**MINUTES OF THE MEETING
June 19, 2008**

**Seattle
Design
Commission**

Project: 1200 Stewart

Phase: Alley Vacation

Figure 1: Current building design

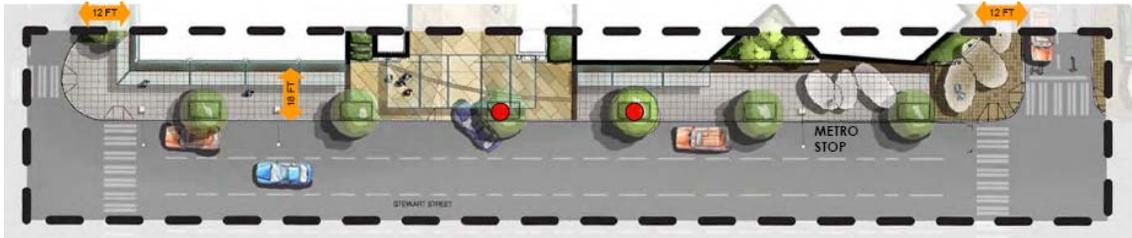
- **The base of the building appears rather massive and not very porous. Consider using smaller forms, lowering the scale to a pedestrian level and increasing functional and visual connections through this development.**

- **More design attention needs to be paid to the service area, the blind façade portion of the corner and the relationship with the public realm, as well as the retail on the Yale corner and the relationship to the Metro stop.**

- **We encourage further exploration of the sidewalk garden areas on both corners of Denny.**
- **We encourage the design team to clarify the character of the “Main Gate” element on Denny, which incorrectly suggests it is the principal entrance. This reference is not consistent and might create a wayfinding conflict with a drop off area, pedestrian circulation and public space.**

Figure 3: Improvements at Denny and Minor

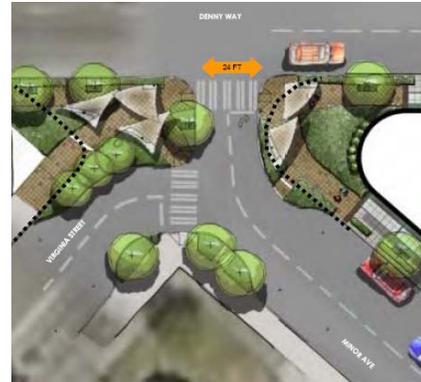
- **12 ft. sidewalks on Denny are not adequate as this is a primary pedestrian route between Capitol Hill and Downtown. Work closely with the city and stakeholders group to get feedback and go forward with some of their recommendations. Consider a building setback on both Minor and Denny as a potential public benefit.**
- **Maintain consistency with DPD's Plan for Denny Way to the extent such plans exist. The team may have to take the initiative in proposing a sidewalk program to be used more broadly along Denny Way.**
- **Concern that the rain gardens in the street right-of-way may present a barrier and make the walkways additionally tight.**

- **Work with SDOT on the location of pedestrian crossings on Denny Way. Their locations will have an important impact on the pedestrian flow around the building. The reconfiguration of Pontius on the north side of Denny Way may provide an opportunity to create a new crossing.**

- **Consider `consolidating the driveways and curb cuts on Minor. The Commission appreciates the narrowing of the pedestrian crossing on Minor and Yale, as well as the bulb-outs and buffer on Denny Way.**
